Access Compliance Report

Public Rights-of-Way

(Curb Ramps)

Intersection ID: 14014	Main Street: N_SHARON_AMITY_RD	Cross Street: WILORA_LAKE_RD	Location: SE
ADA ID: EA50F65FA8DC	Ramp Type: Perp	Initial Pass/Fail: Fail	Overall Compliance: No
Codes/Mitigation Info/Possible Solution		Field Measurements/Component Compliance	
Severity Score: 21.25

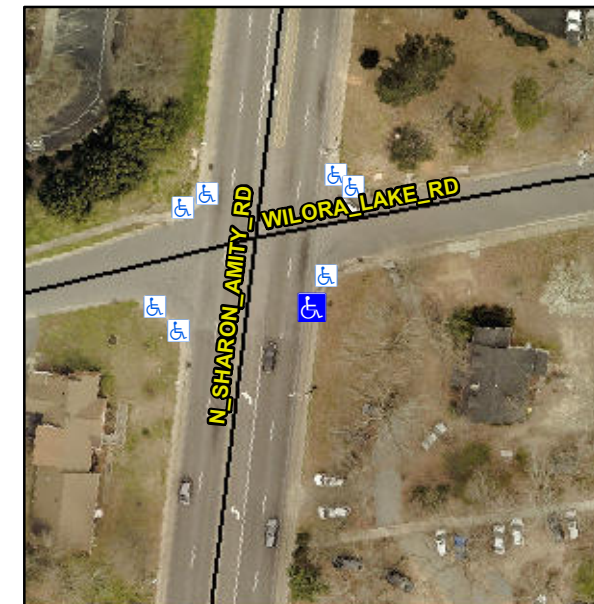
Not Found, R304.5.1, R304.2.2

Compliance	Description	Data	Compliance	Description	Data
N/A	Ramp Length (in)	59.0	No	Ramp Slope (%)	9.5
No	Ramp Width (in)	44.0	Yes	Ramp XSlope (%)	0.2
N/A	Flare Type LT	N/A	N/A	Flare Type RT	N/A
N/A	Flare Slope LT (%)	N/A	N/A	Flare Slope RT (%)	N/A
N/A	Flare Traversable LT?	N/A	N/A	Flare Traversable RT?	N/A
N/A	Landing Length (in)	N/A	N/A	DWS Provided?	N/A
N/A	Landing Width (in)	N/A	N/A	DWS Contrast?	N/A
N/A	Landing Slope (%)	N/A	N/A	DWS Length (in)	N/A
N/A	Landing X Slope (%)	N/A	N/A	DWS Full Width?	N/A
N/A	Landing Curb? (Y/N)	N/A	N/A	DWS Offset (in)	N/A
N/A	Shared Landing?	N/A			
N/A	Gutter Ponding?	N/A	N/A	Gutter Slope (%)	N/A
N/A	Gutter Lip Ht (in)	N/A	N/A	Gutter X Slope (%)	N/A
N/A	Painted X Walk1?	No	N/A	Painted X Walk2?	N/A
	X Walk 1 Direction	To W		X Walk 2 Direction	N/A
N/A	X Walk 1 Width (in)	N/A	N/A	X Walk 2 Width (in)	N/A
	X Walk 1 Slope (%)	4.6		X Walk 2 Slope (%)	N/A
	X Walk 1 X Slope (%)	1.9		X Walk 2 X Slope (%)	N/A

Remove & Replace Entire Ramp.
